Water Right Conditions Tracking Slip

FILE # # 15951

TO: Water Rights Section JUNE 5, 2003
 FROM: Ground Water/Hydrology Section IVAN GALL
 SUBJECT: Application G- 15951 Reviewer's Name IVAN GALL
 Supersedes review of N/A Date of Review(s)

A. **GENERAL INFORMATION:** Applicant's Name: ROBERT & BARBARA LOER

G-15951

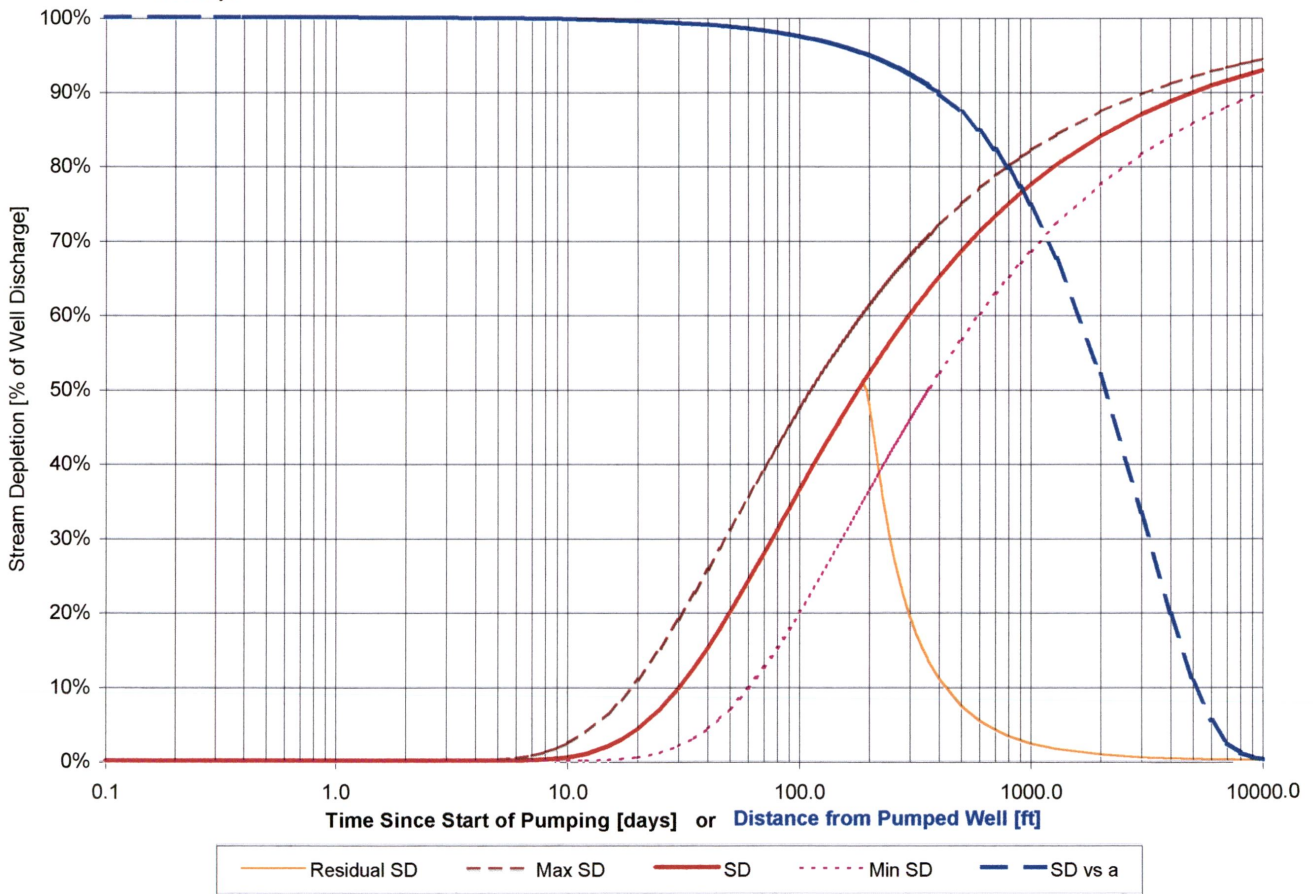
Comments: *Simple analytical results with low K and high S estimates, suggest 10% impact after 30 days pumping. Not all analytical model assumptions met, however, K & S values adjusted accordingly to make a more conservative estimate of impact. Initial T & S estimates from Blandan ag. test analysis (G-15943).

Basis for impact evaluation: simple analytical model as described above using ag. test data from Blandan (G-15943). However, ag. test conducted on weathered (adjacent to Loe) suggests more than one well in area

(c) The **percentage** of appropriation in the first year of use that will be at the expense of surface water 50%

Basis: Simple analytical modeling as described above.

C7. SW / GW Remarks * Permittee shall install and maintain a properly functioning, totalizing flow meter.
